Former ASARCO East Helena Facility Interim Measures Work Plan— Conceptual Overview of Proposed Interim Measures and Details of 2012 Activities

Prepared for
The Montana Environmental Trust Group, LLC
Trustee of the Montana Environmental Custodial Trust

Revised September 2012

- **Appendix C** contains public comments on the June 2012 draft *Former ASARCO East Helena Facility Interim Measures Work Plan—Conceptual Overview of Proposed Interim Measures and Details of 2012 Activities*, followed by USEPA responses. Comments were received from the Lewis and Clark County Water Quality Protection District, James Schell, the Lewis and Clark City-County Health Department, and the State of Montana (Montana Department of Justice and Montana Department of Environmental Quality).

FIGURE 3-8
Dissolved Arsenic Concentrations in Groundwater
October-December 2010
Interim Measures Work Plan-2012 Draft
 Phase II RFI Report
 East Helena, Montana

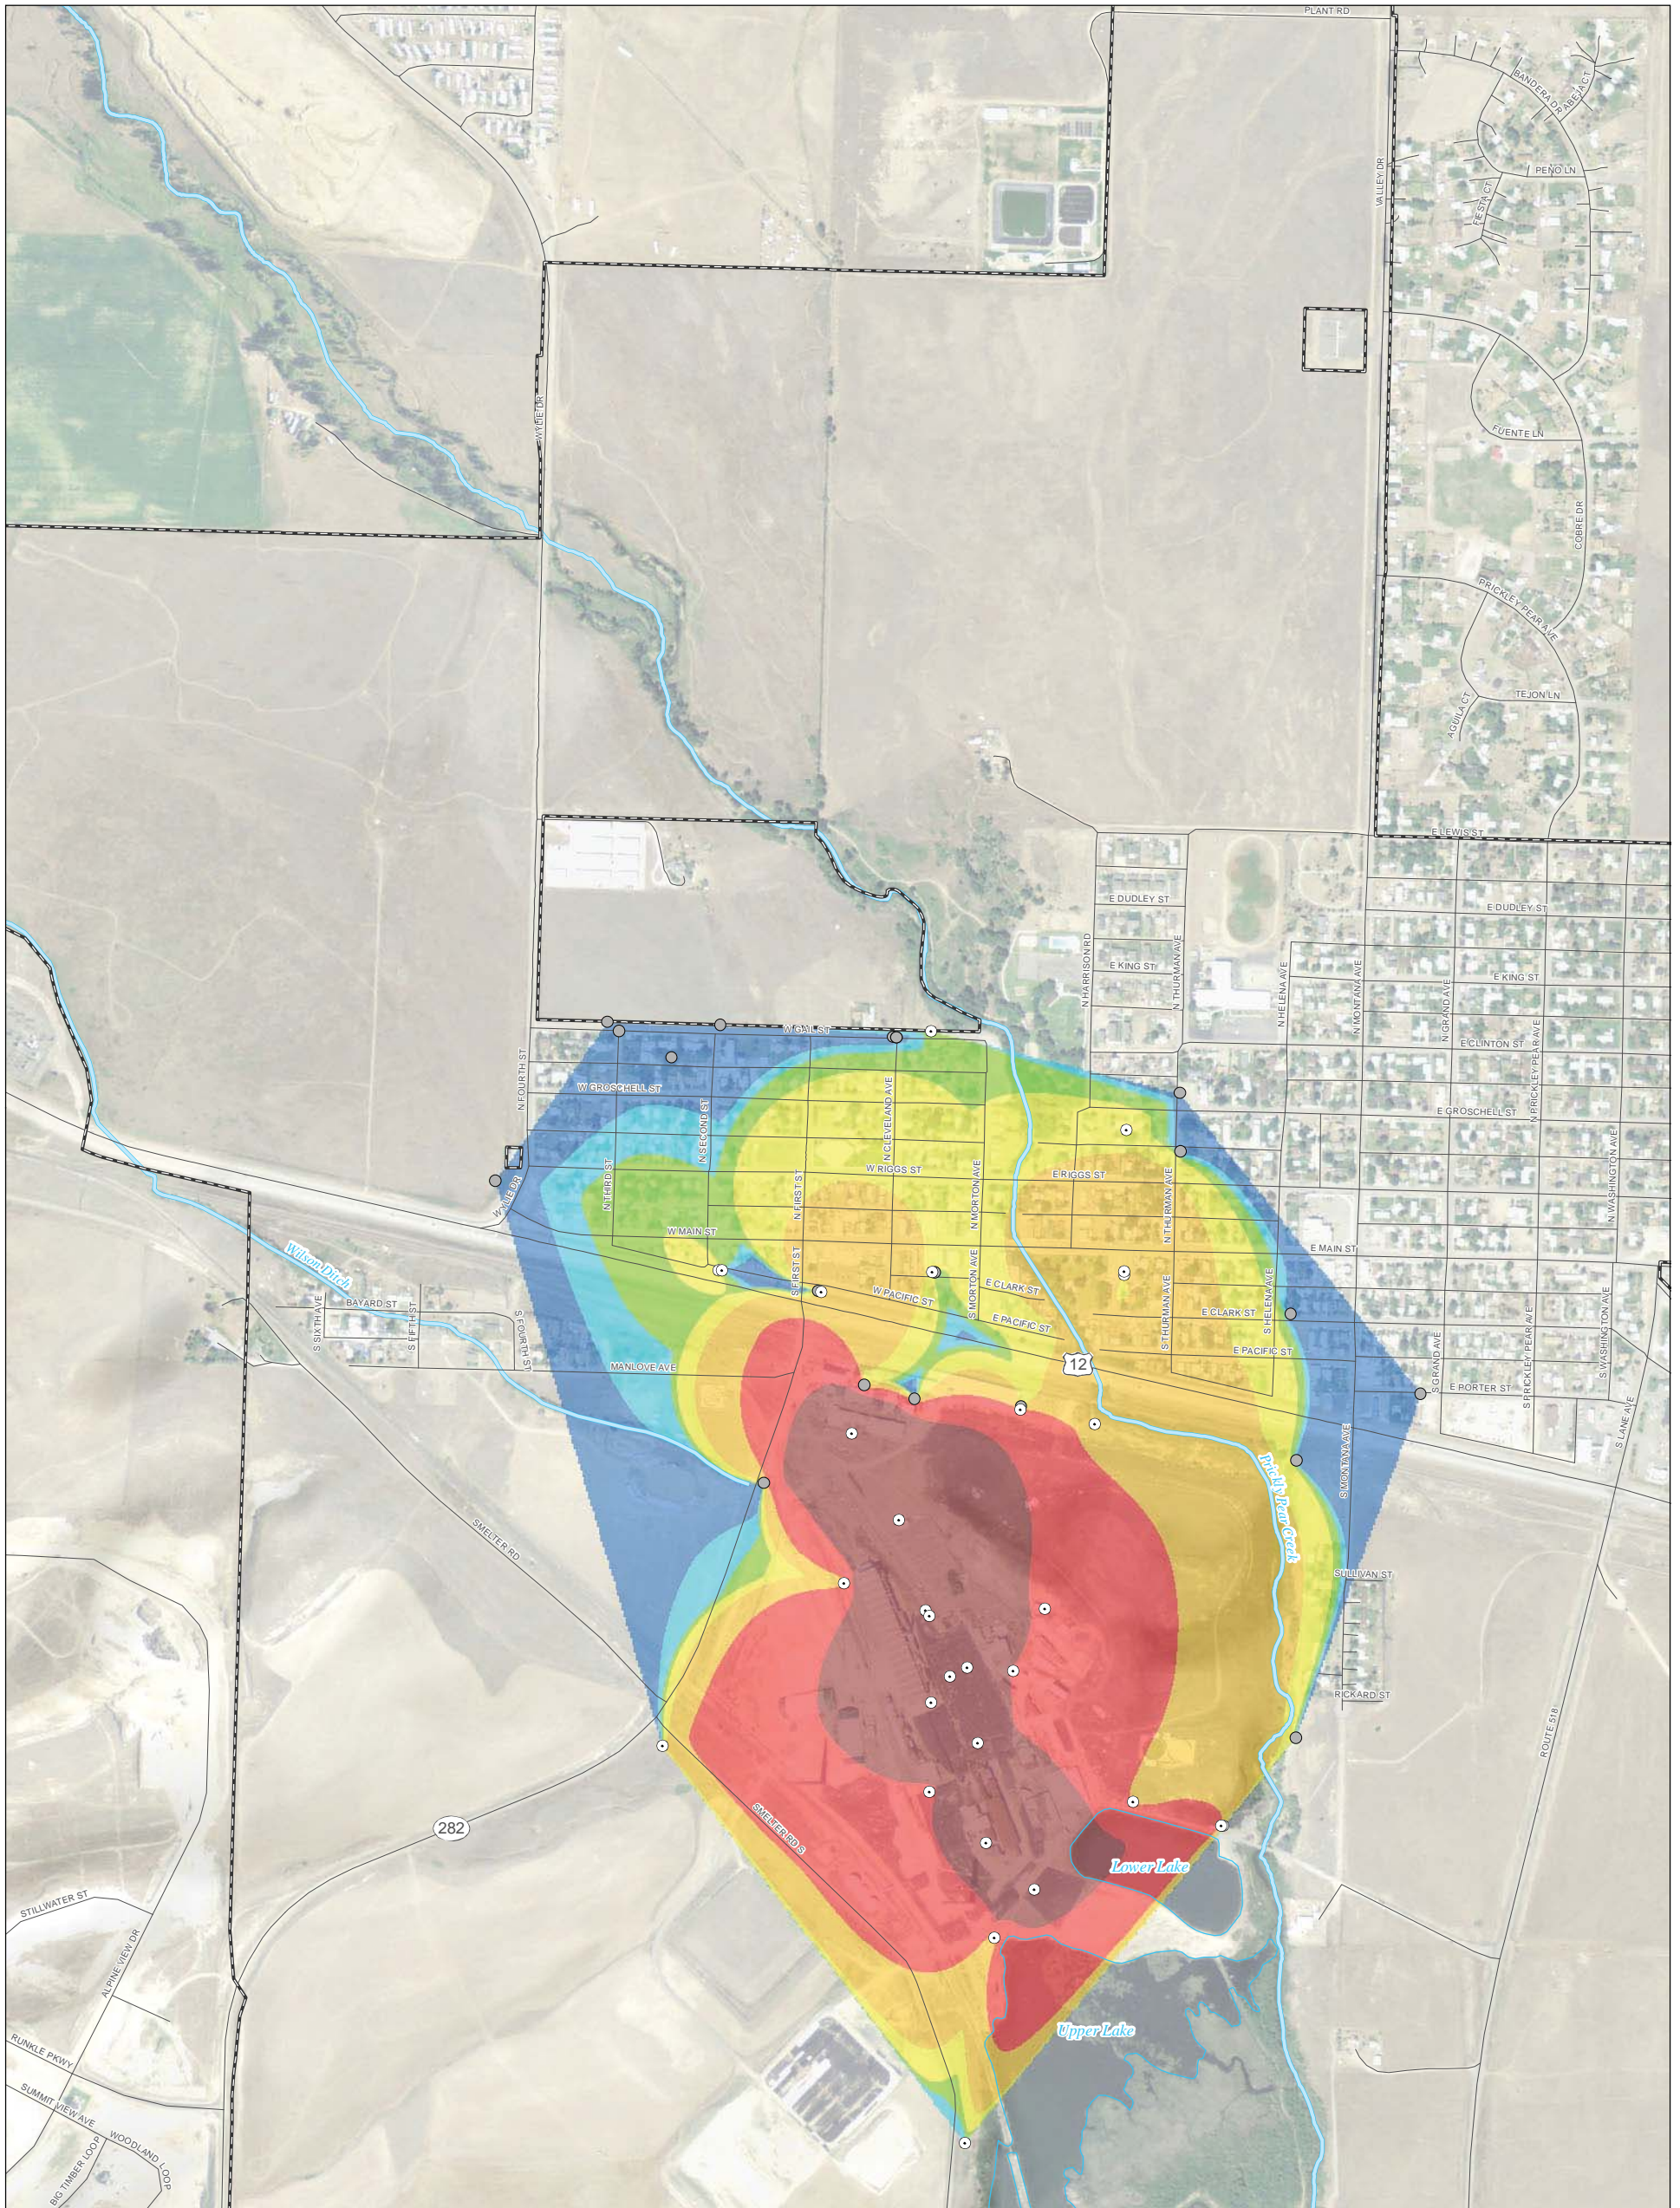
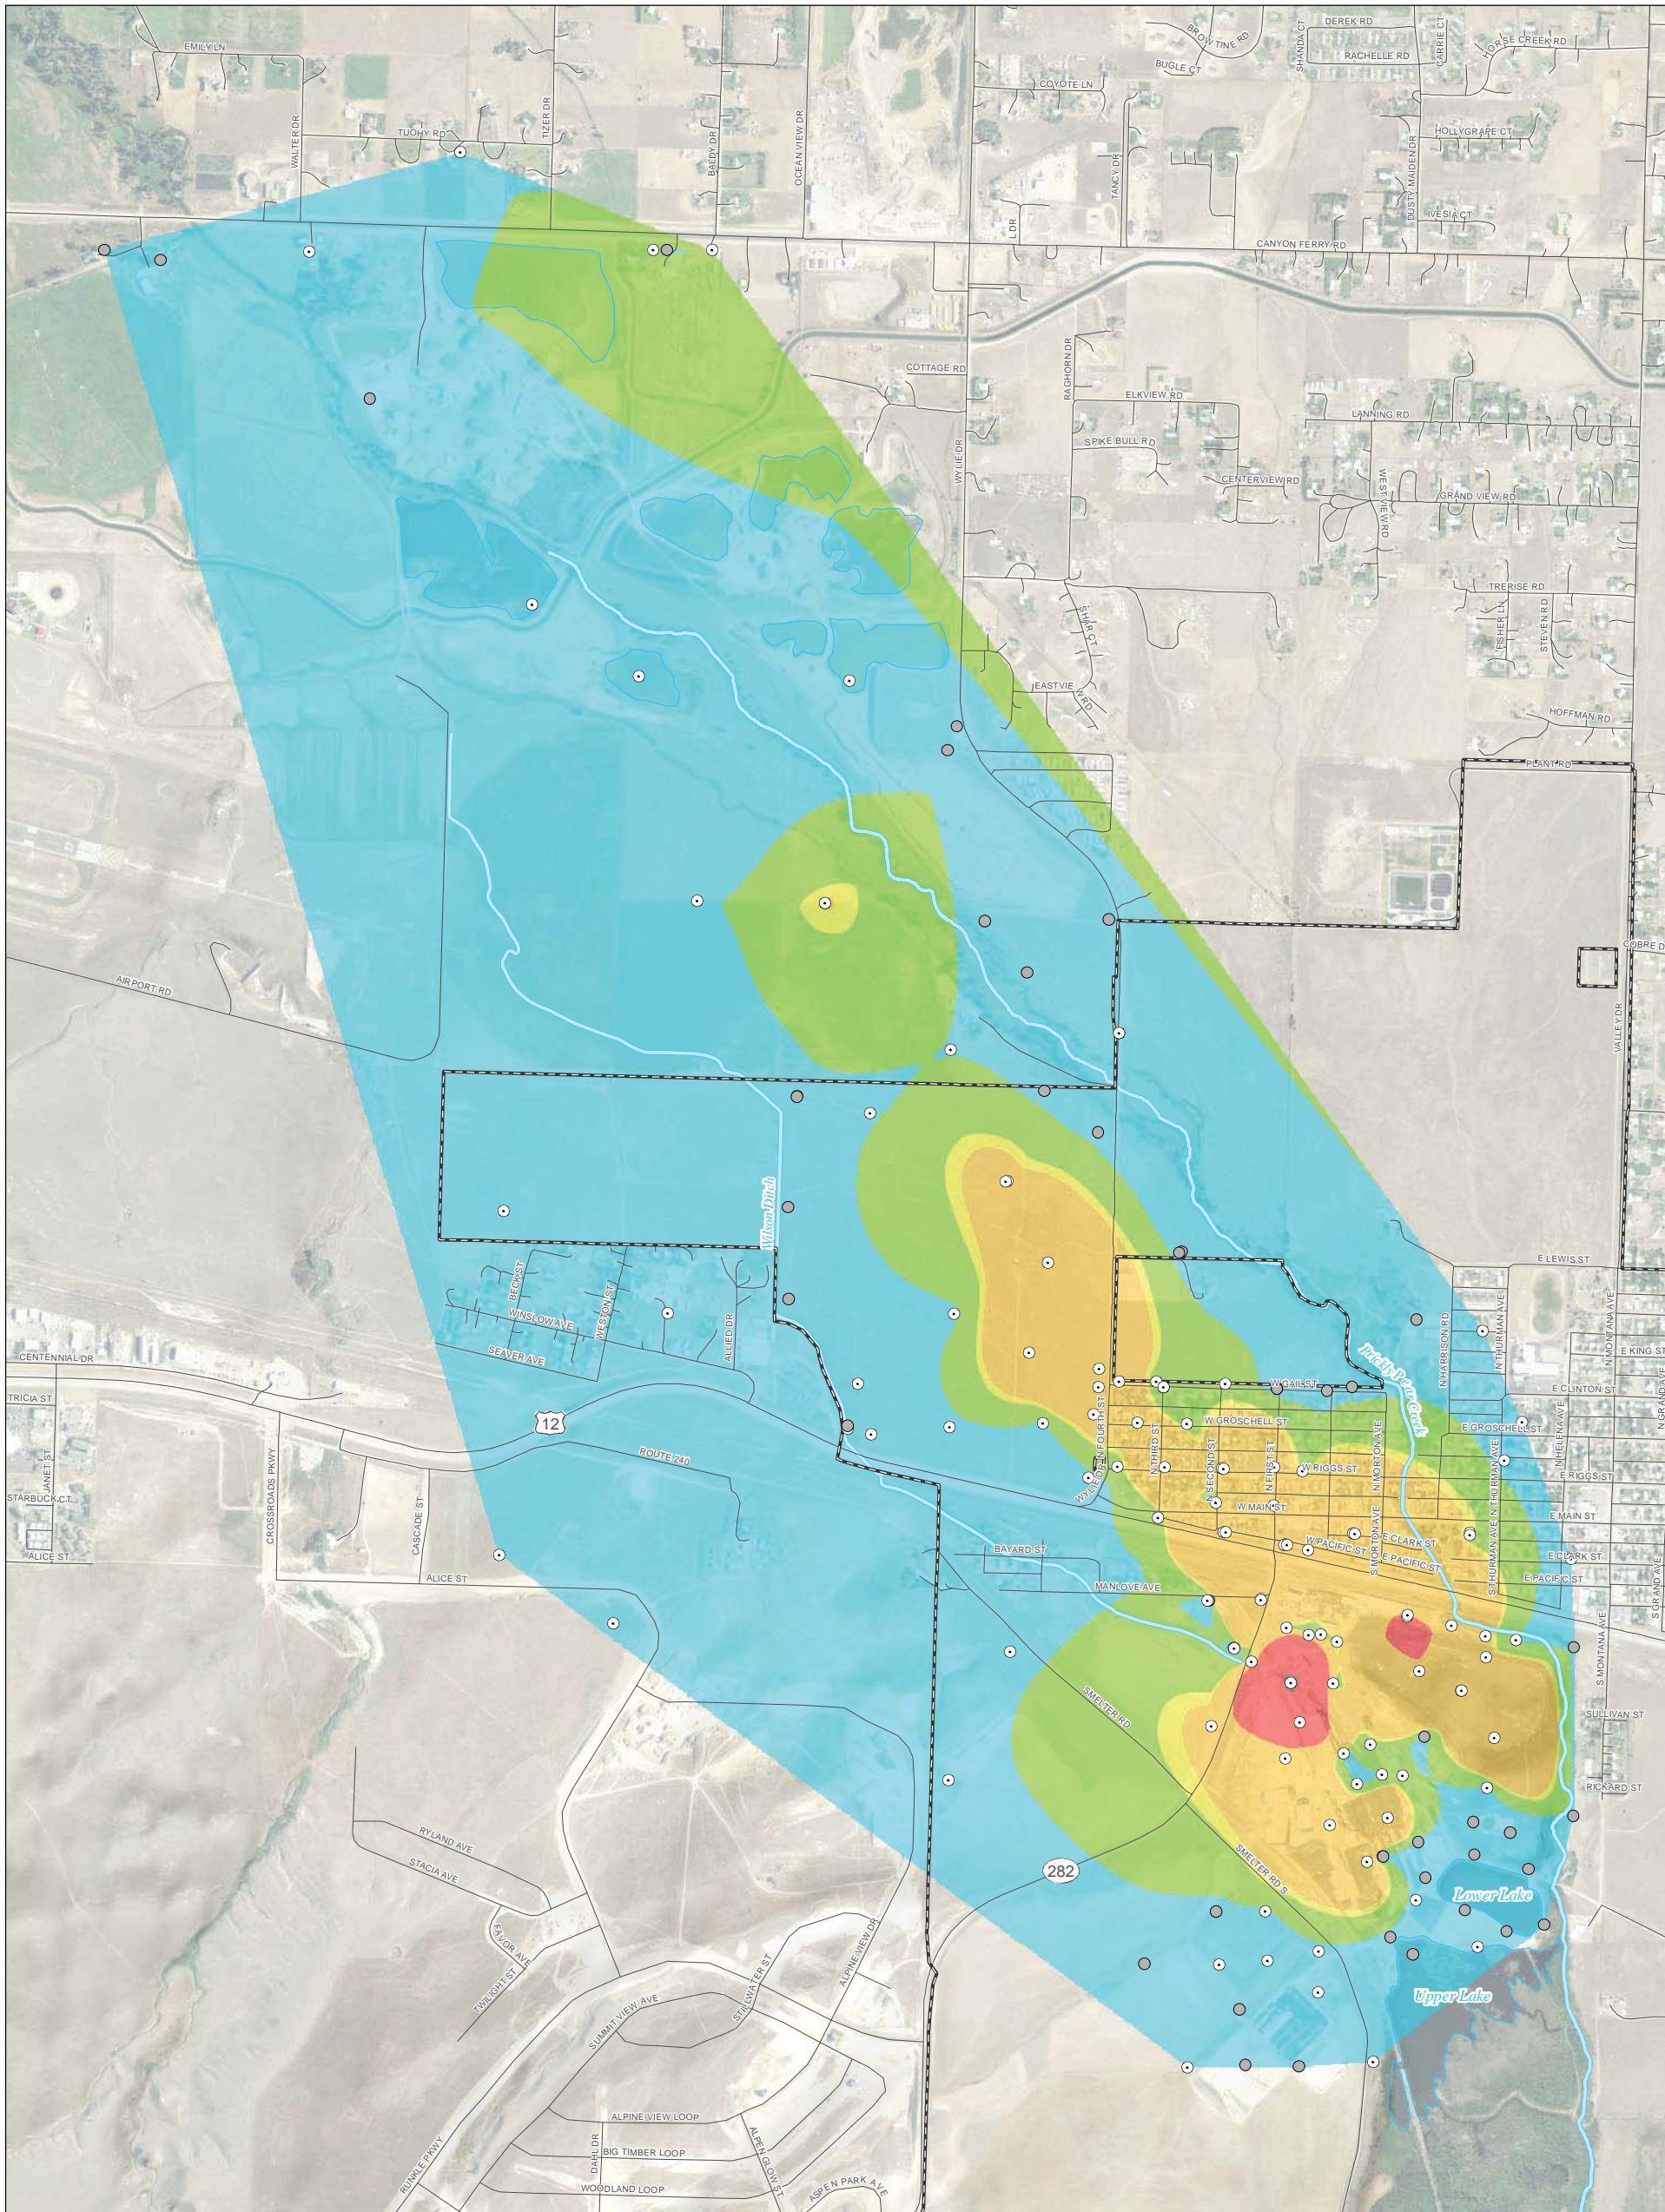
18. A regional background level for Arsenic is indicated on Figure 3-8 and 3-9 as 17 ug/L. There is no indication for how this concentration was determined. WQPD well data would not support this conclusion. The background level for this type of site should be determined based on site-specific upgradient conditions.

Figure 4. South Plant Area Water Level Response to Upper Lake Dewatering

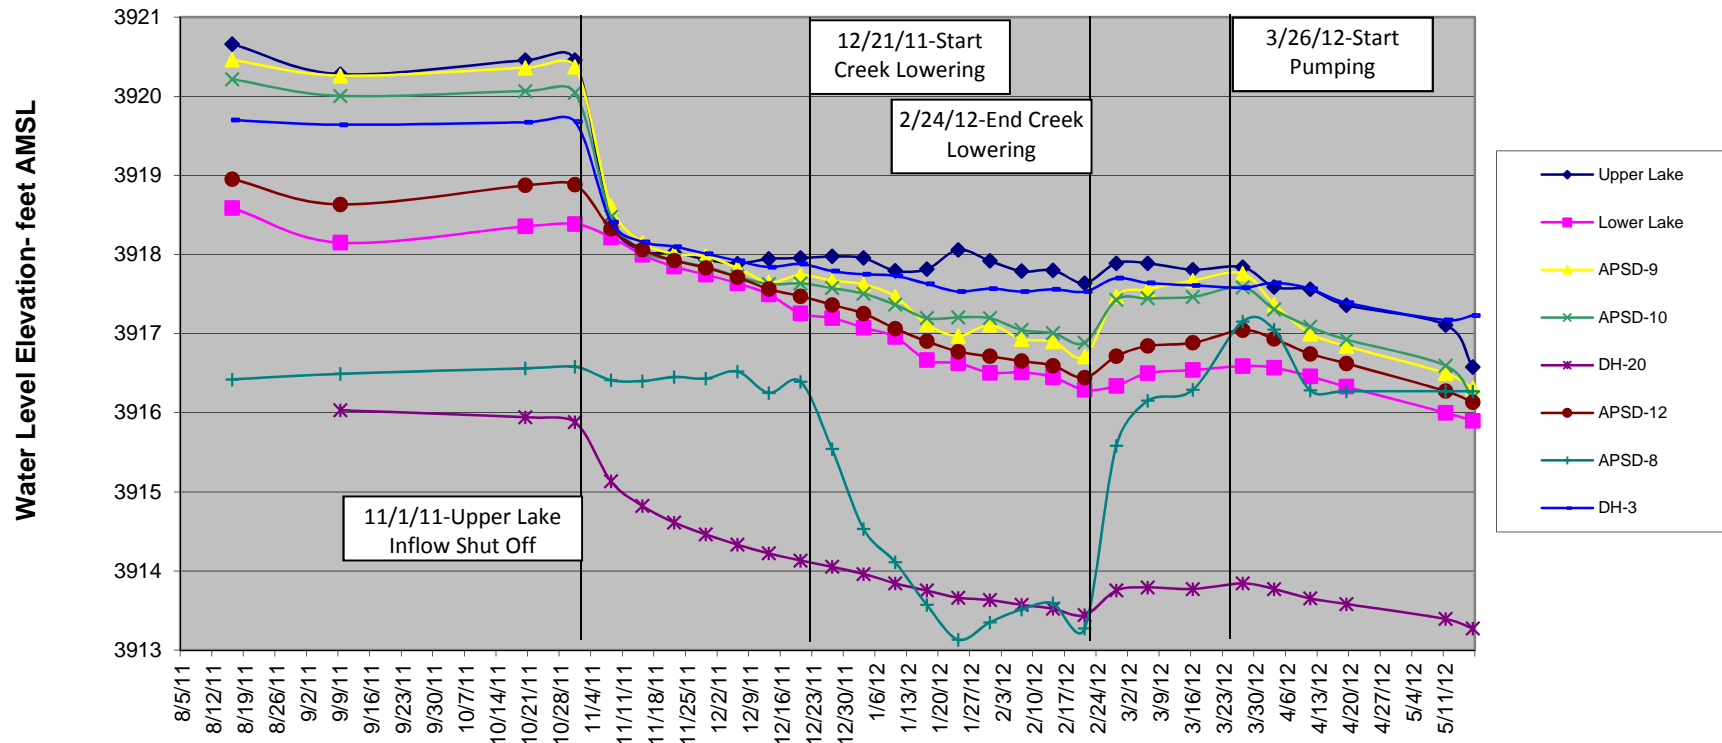
The second sentence in the final paragraph on the third text page of Appendix A contains the date "2/21/11". I believe this date should be "2/24/11" to match the two accounts of this date on the previous page and Figure 4 of the same appendix.
